Silverado Series SV6000

Penn Reel Parts list for Model: SV6000 Silverado Series

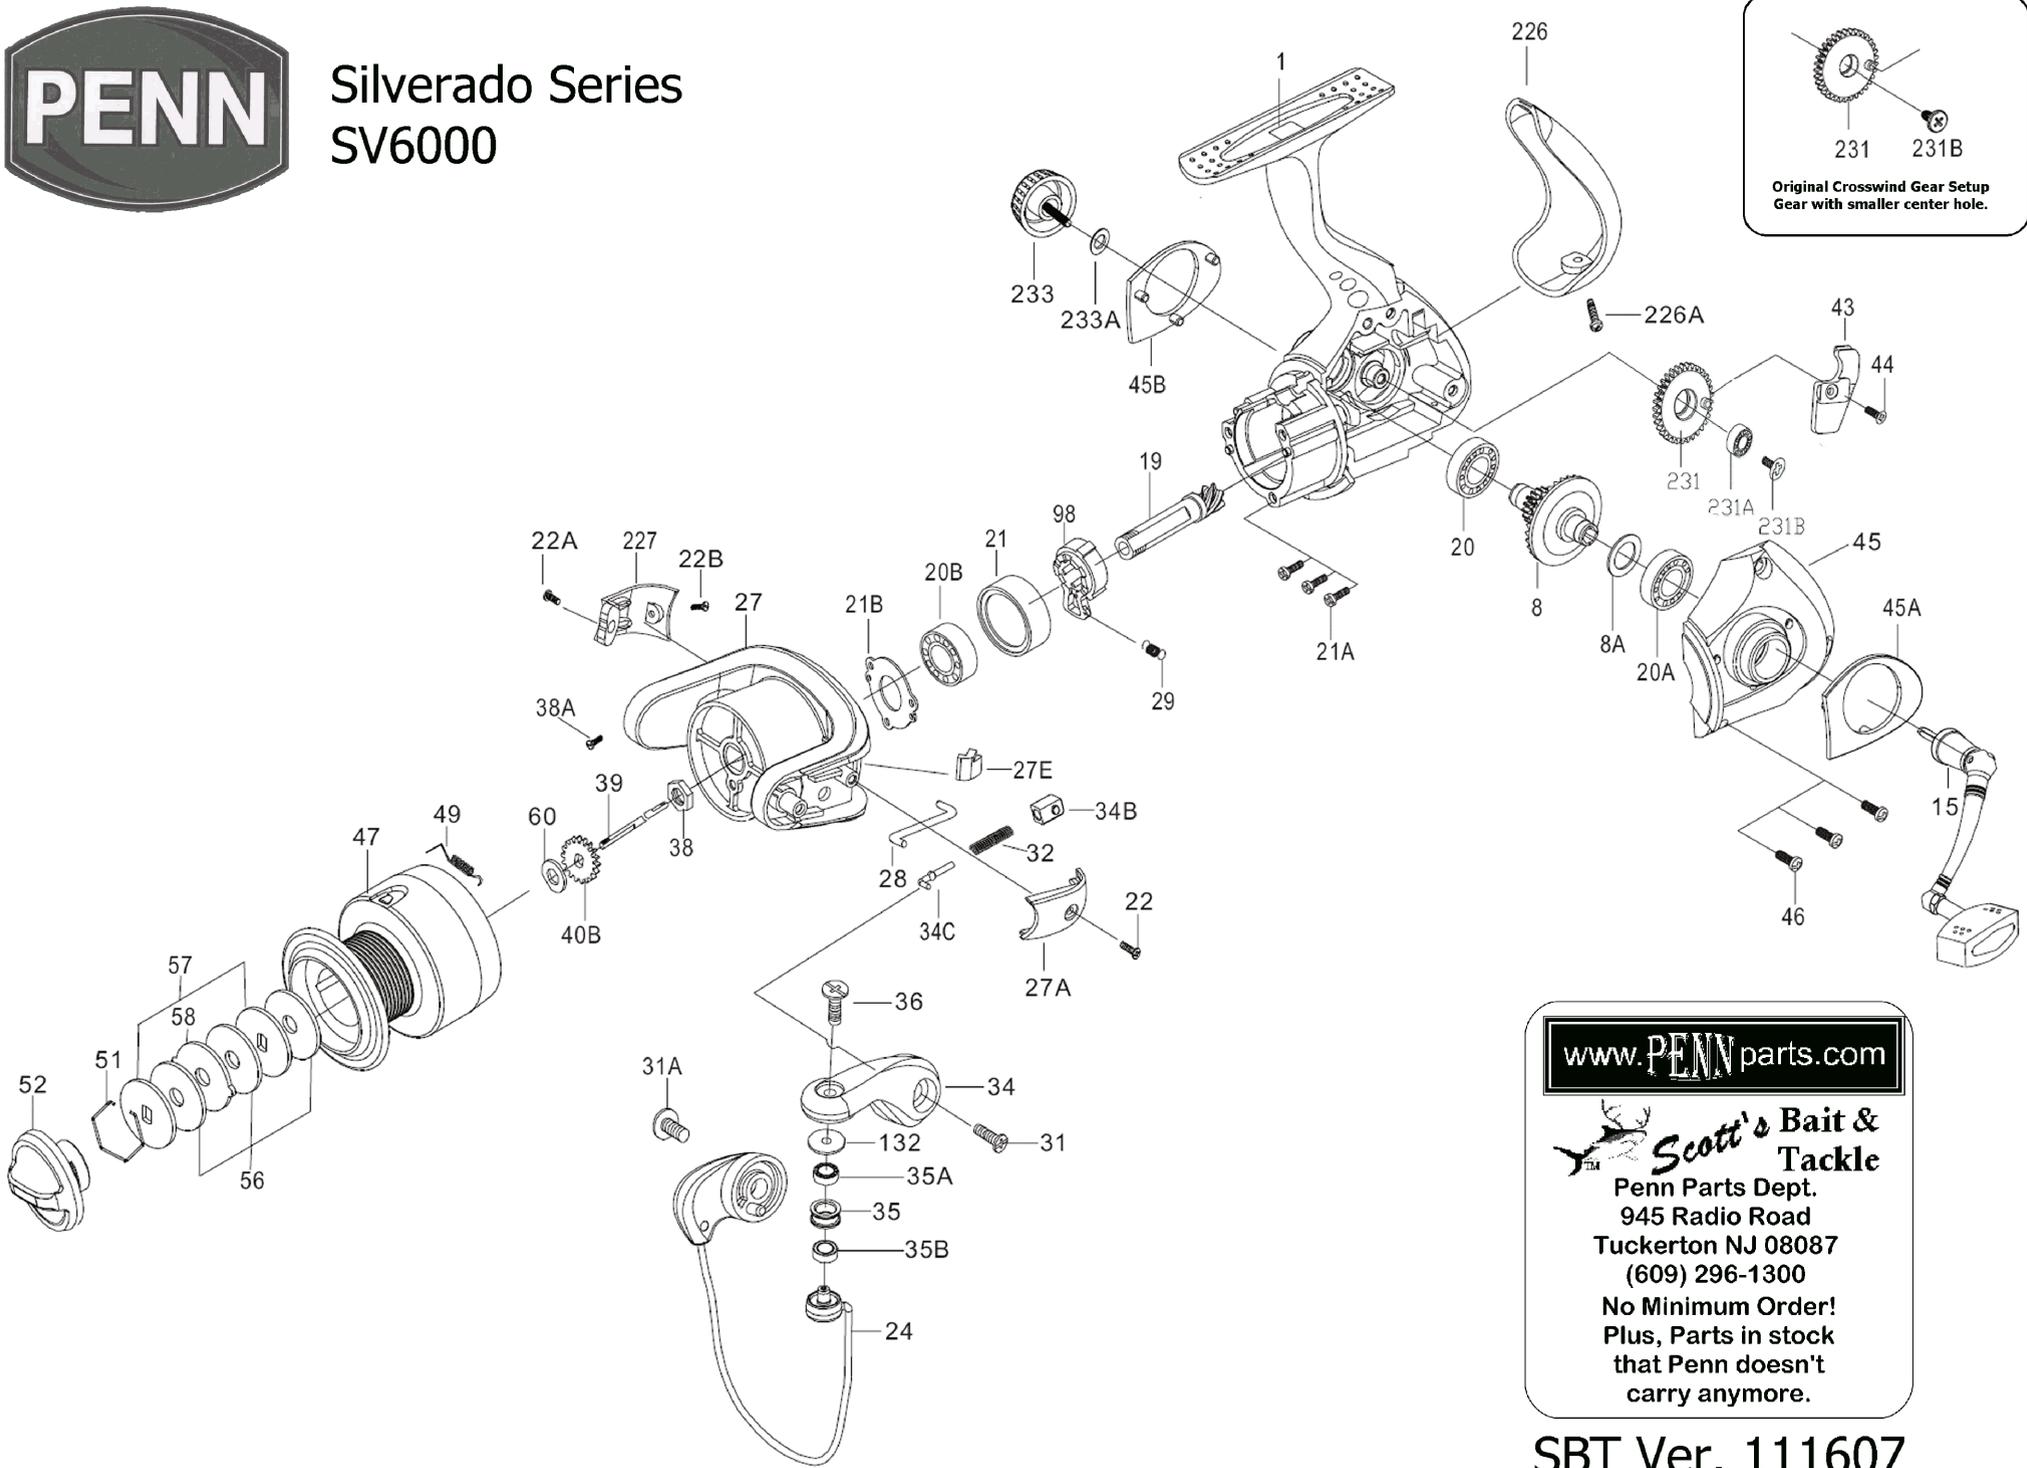
The original 231-5000SV crosswind gear had a small hole to fit on the housing.
The newer 231-5000SV have a larger hole that sits the 231A-4000CV bearing
